ABS Check Cales

LILCO Shoreham Plant - Emergency Diesel Gen - DeLaval/Enterprise DSR-48

Check of Fractional Vibration

Figure 3-1. Goodman diagram for replacement crankshafts.

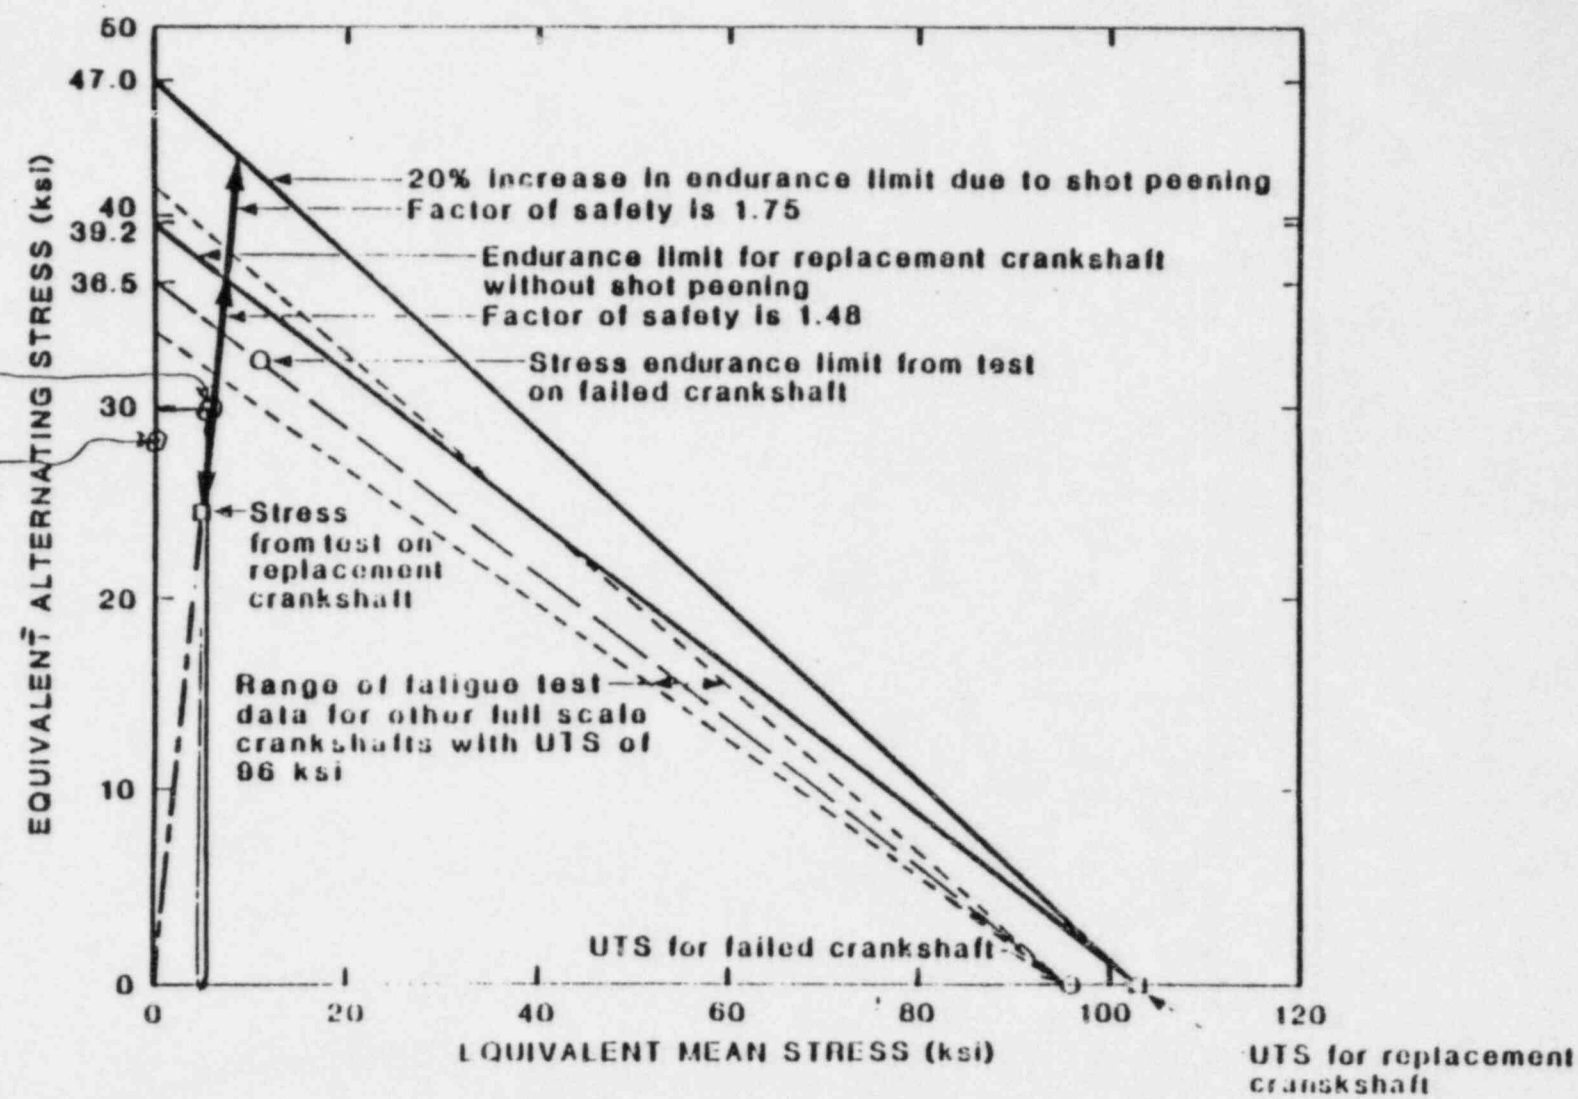
Safety Factors - desired minimum = 1.34 - lowest
for spec
review of
another
mfr.

Fatigue Stress = 29940 psi

Fatigue Strength = 33083 psi (theoretical CIMAC) \rightarrow S.F. = 1.105

39200 psi (submitted - no shot peen) \rightarrow S.F. = 1.309

47000 psi (shot peened) \rightarrow S.F. = 1.570

Steady Stress = ~~5000~~ 5313.5 psi \rightarrow S.F. = ~~14.83~~ 18.960

Combined S.F. - Goodman method $\left(\frac{1}{SF} = \frac{1}{SF_{fatigue}} + \frac{1}{SF_{ult}} \right)$

For CIMAC ^(theoretical) fatigue limit \rightarrow 1.044 (LOW)

For submitted F.L. - no shot peen \rightarrow 1.224 (LOW/MARGINAL)

For submitted F.L. - w/shot ~~peening~~ ^{peening} \rightarrow 1.450 (OK)

Combined S.F. - Elliptical method $\left(\frac{1}{SF^2} = \frac{1}{SF_{fat}^2} + \frac{1}{SF_{ult}^2} \right)$

For CIMAC ^(theoretical) fatigue limit \rightarrow 1.103 (LOW)

For submitted F.L. - no shot peen \rightarrow 1.306 (OK) (^{but} marginal)

For submitted F.L. - shot peened \rightarrow 1.565 (OK)

Conclusions

- 1) Based on submitted fatigue strength data and test results, proposed torsional vibration arrangements are OK.
- 2) Note that submitted fatigue strength is higher than that obtained by CIMAC formula.
- 3) Note also that submitted stress^{test} results show ~~the~~ lower stresses than those calculated by either CIMAC or ABS formulas
